**APPENDIX L**  
**TANSLEY BRIDGE CONSTRUCTABILITY REVIEW REPORT**

# TANSLEY BRIDGE CONSTRUCTABILITY REVIEW REPORT

## Dundas Street (Regional Road 5) Transportation Corridor Improvements Brant Street to Bronte Road

Class Environmental Assessment

TITLE	
GENERAL ARRANGEMENT TANSLEY BRIDGE WIDENING BURLINGTON - HALTON OVER BRONTE CREEK	
Consultant File Nº	Regional Drawing Nº
CONTRACT Nº	Drawing Nº
PR-	SHEET OF

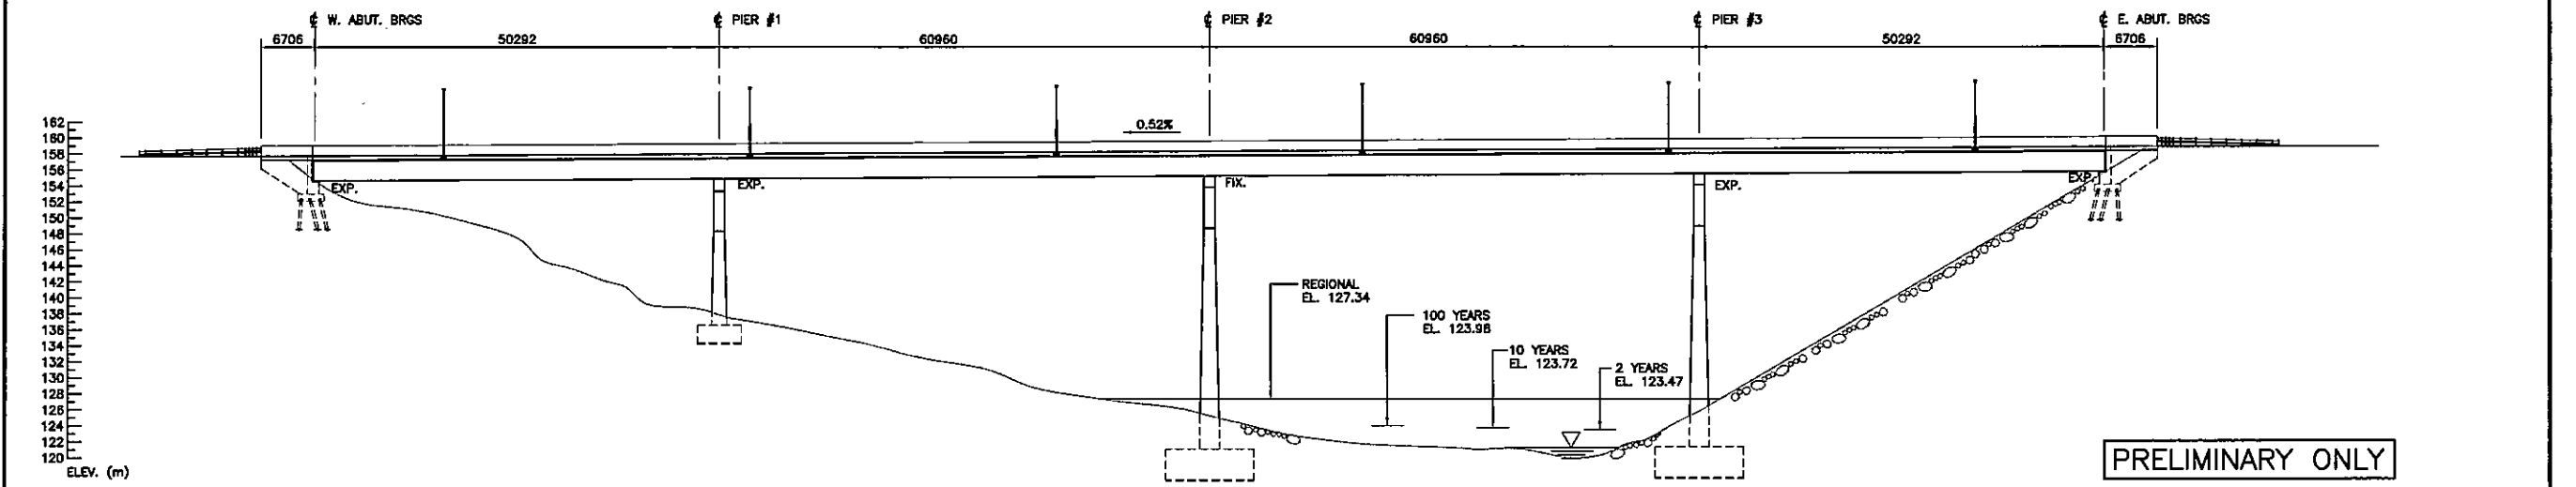
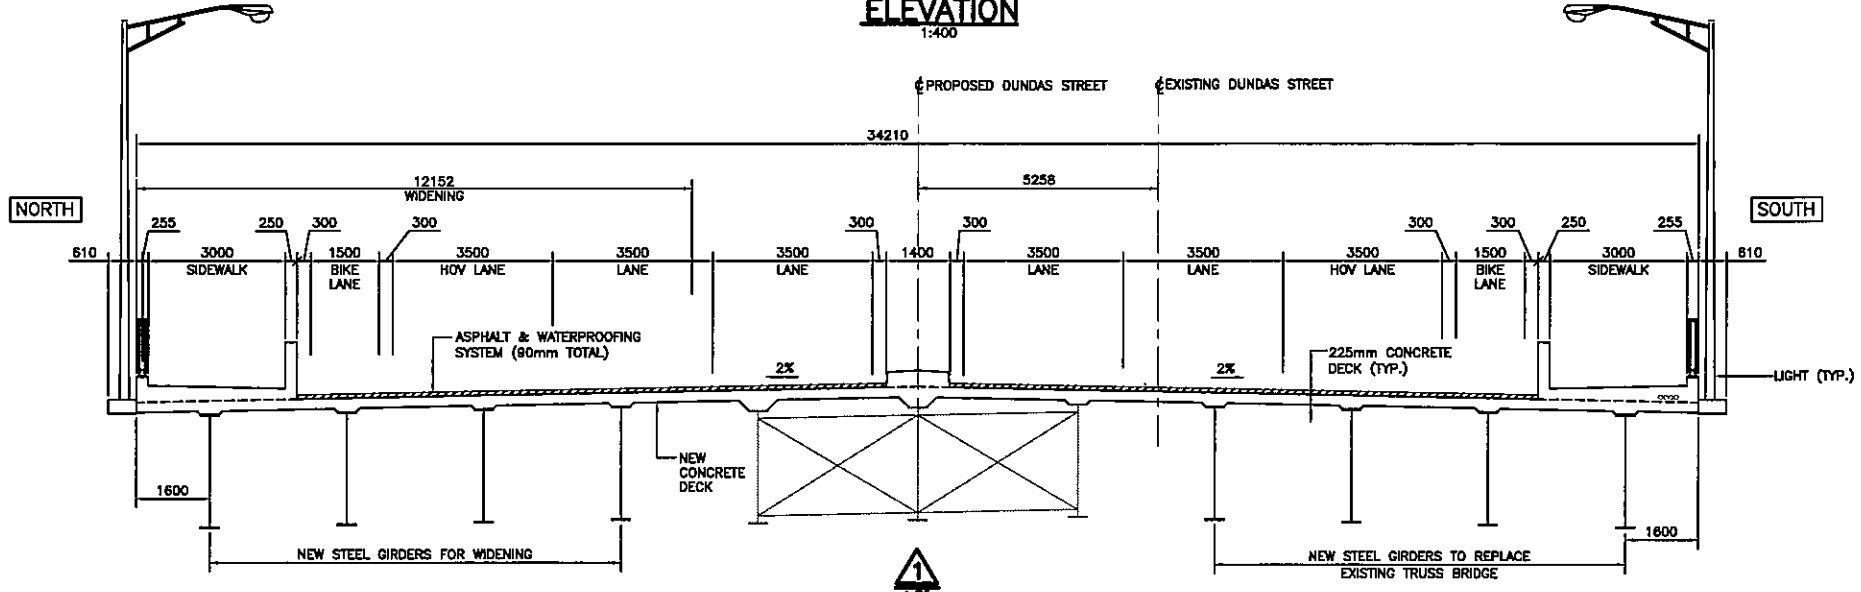
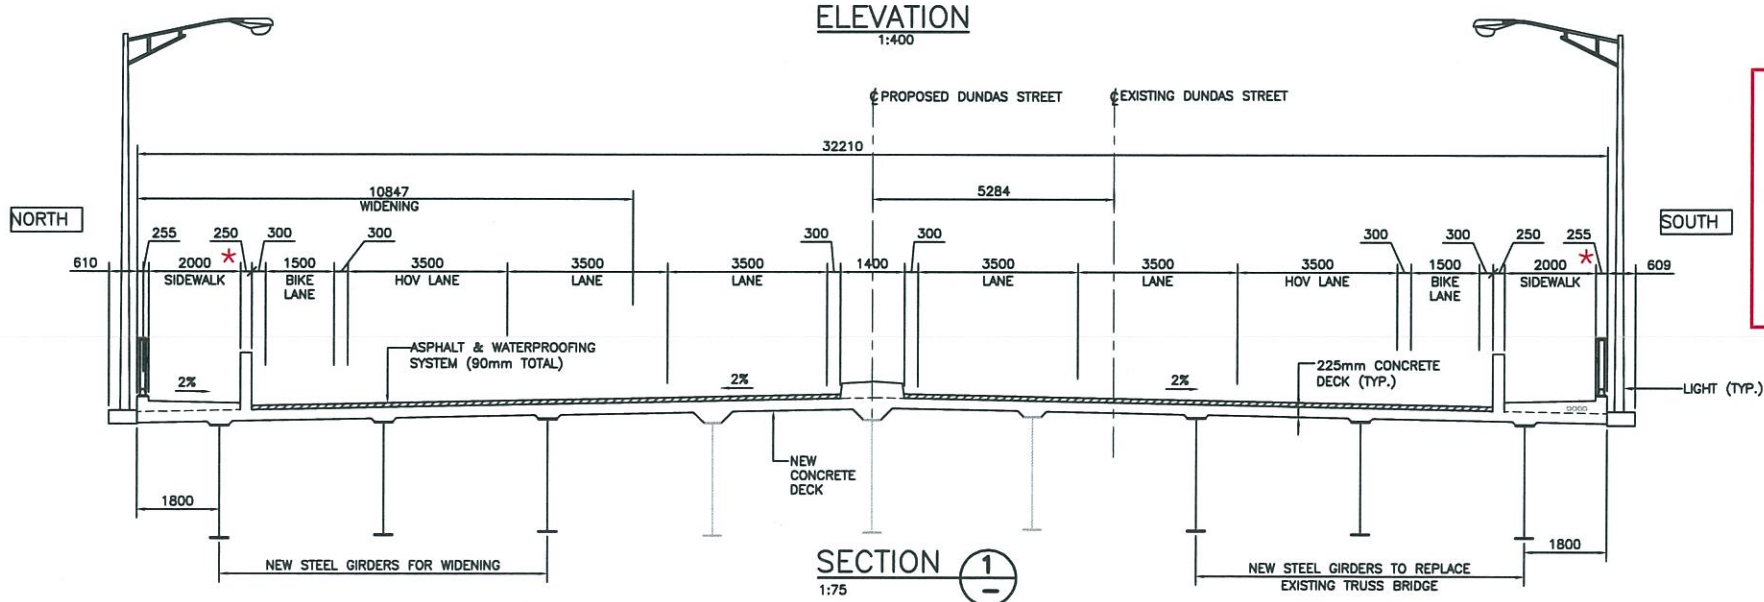
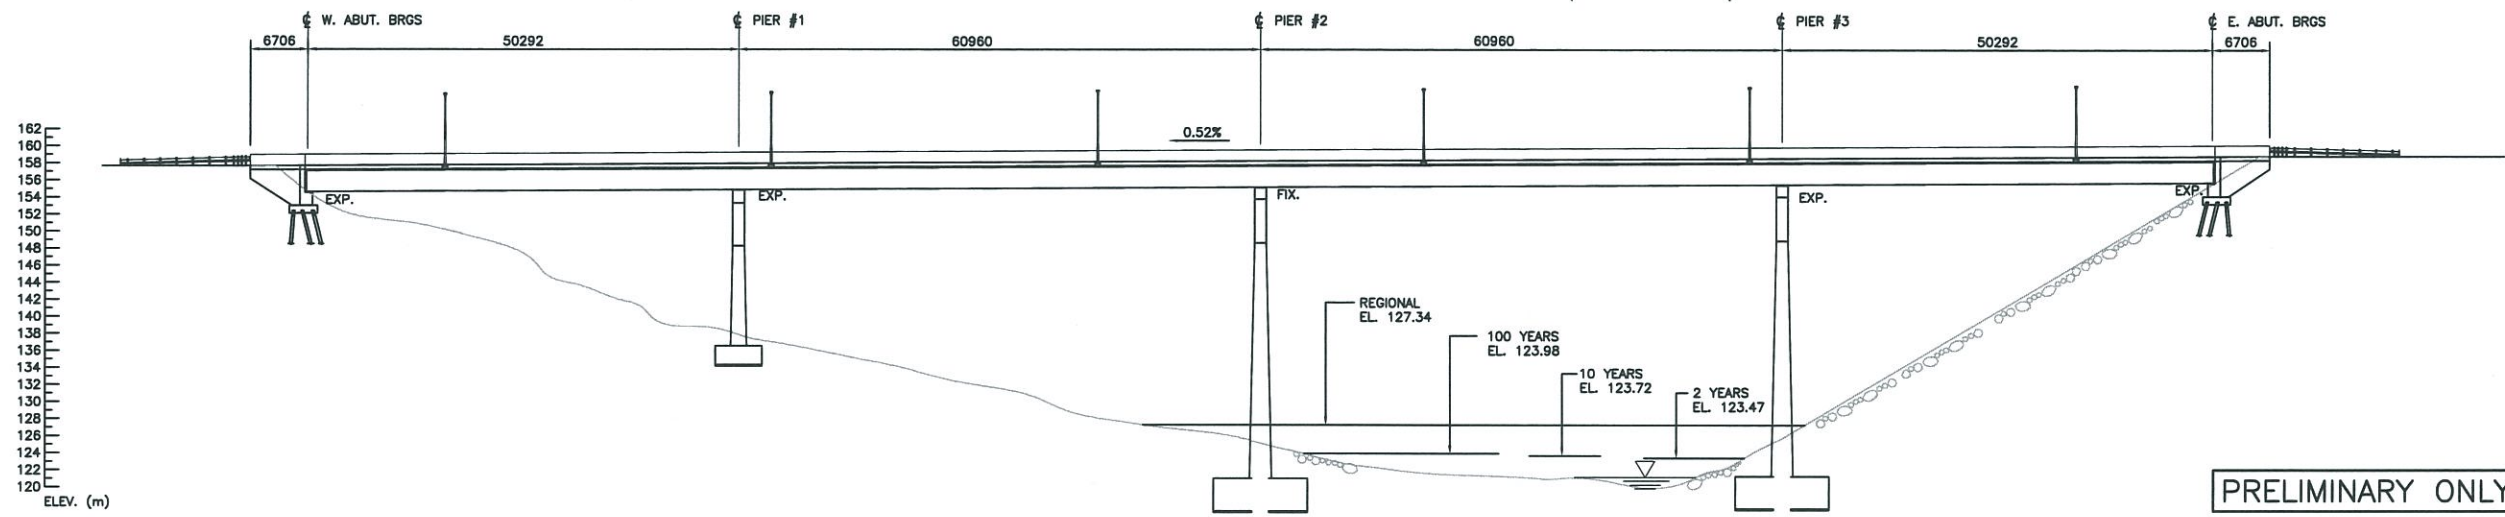
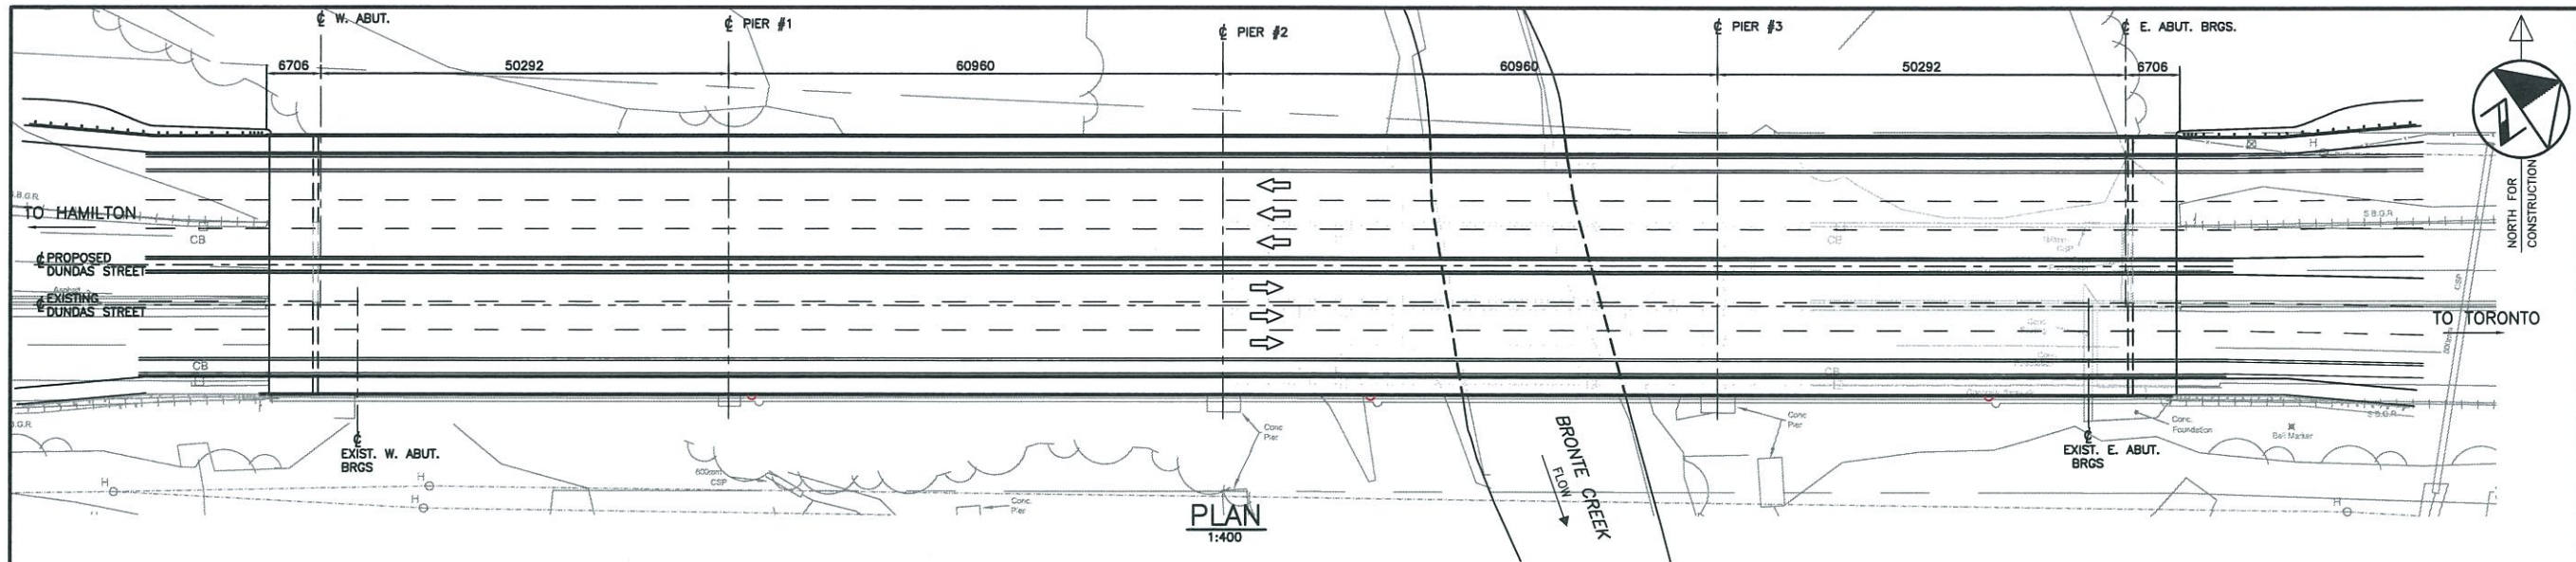
The General Arrangement Drawing provided to the Constructability Review Team prior to the workshop (refer to Appendix C) showed active transportation facilities across the bridge including a 1.5 m on-road bike lane (with 0.3 m buffer strips on either side of it) and a 2.0 m sidewalk on both sides of the road. During the workshop, Regional staff clarified that the sidewalk widths on the bridge were to be 3.0 m.

Subsequent to the workshop, the General Arrangement Drawing was updated to reflect the 3.0 m sidewalk widths on the bridge (refer to Appendix C). The resultant increased width of the bridge lead to the need for an additional line of girders on both sides of the structure. This was anticipated at the workshop. The Constructability Review Team confirmed that discussions with respect to the constructability of the bridge would not be impacted significantly by the increased width of the bridge or the additional girder lines.

\* Sidewalk width revised to 3.0 m at outset of the Constructability Review.

**FIGURE 1**  
PRELIMINARY ONLY

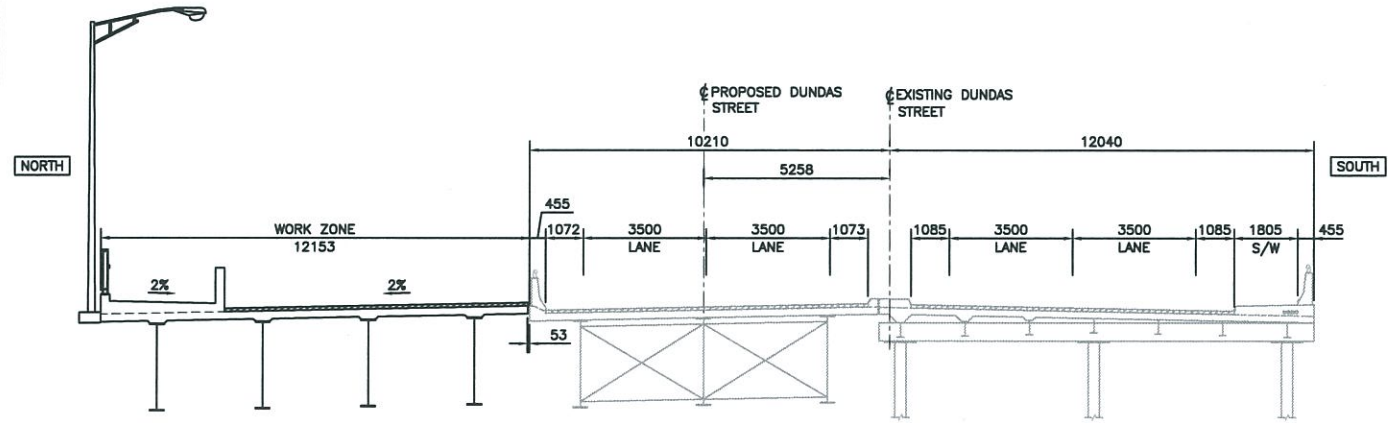
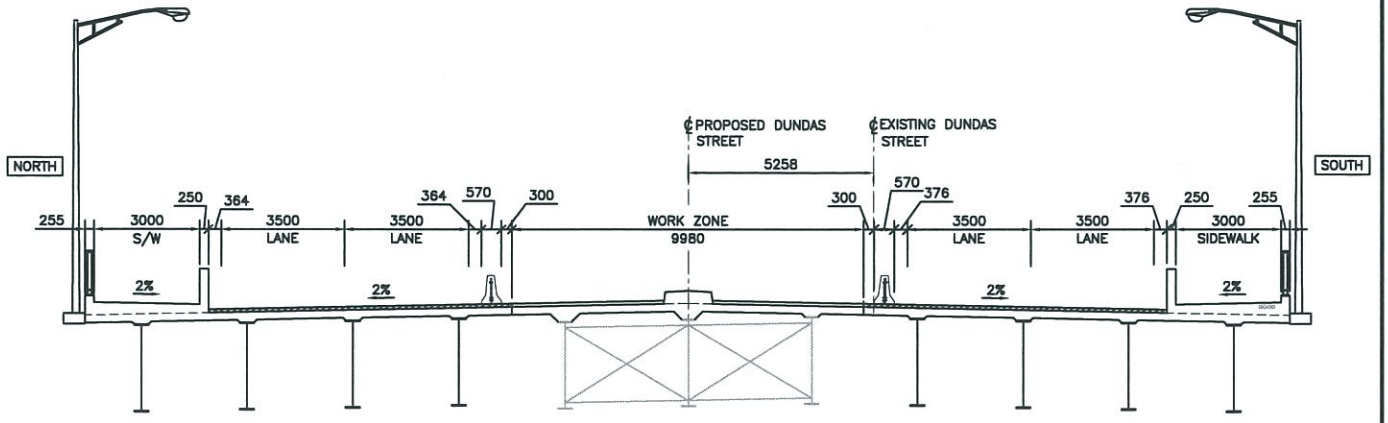
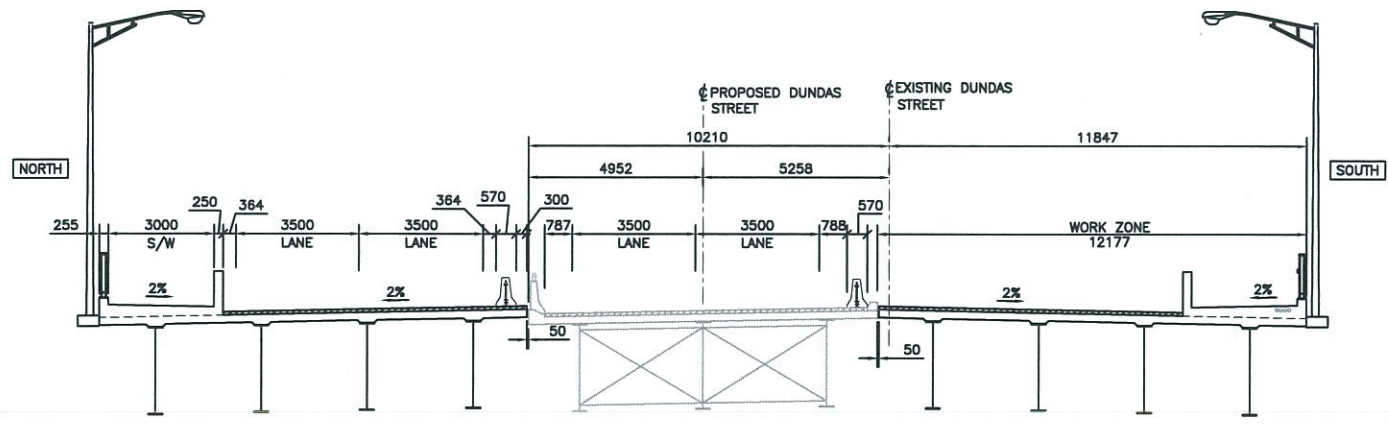
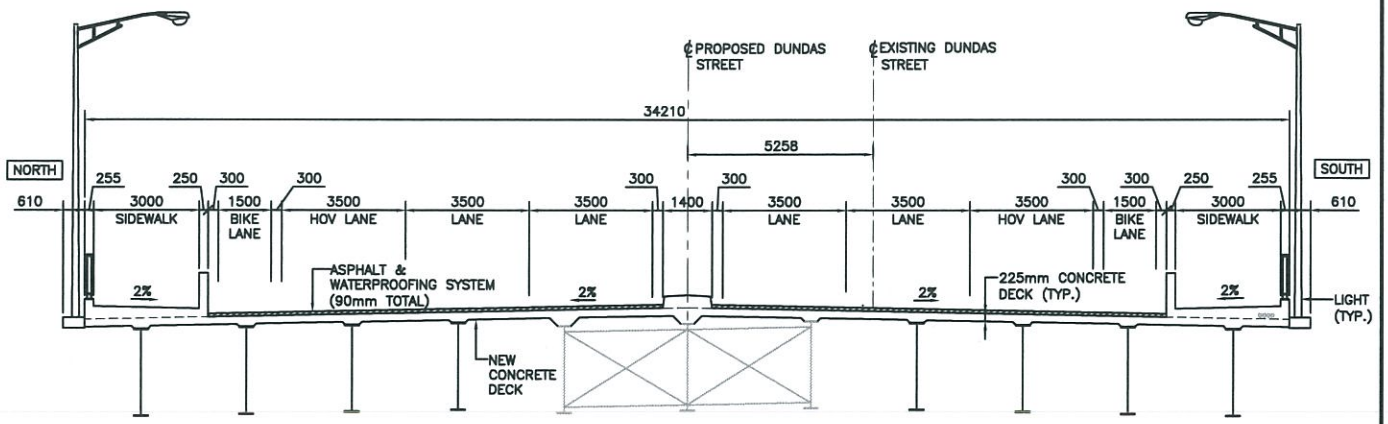
The Constructability Review Team confirmed that the staging proposed by the Project Team was feasible, provided sufficient access to the work areas is provided and that it facilitated the erection of the new steel girders and demolition of the existing truss structure when the lane closure allowances are considered.

Truck access and egress is most problematic in Stage 3 of the construction where the work is being carried out between the active east and west bound lanes. It was agreed that trucks could enter the centre construction area by slipping off the centre lanes (in either direction) at each end of the bridge provided this was done in the off-peak hours. Similarly, egress from the central construction zone can be achieved by slipping on to the centre lanes in off peak hours.
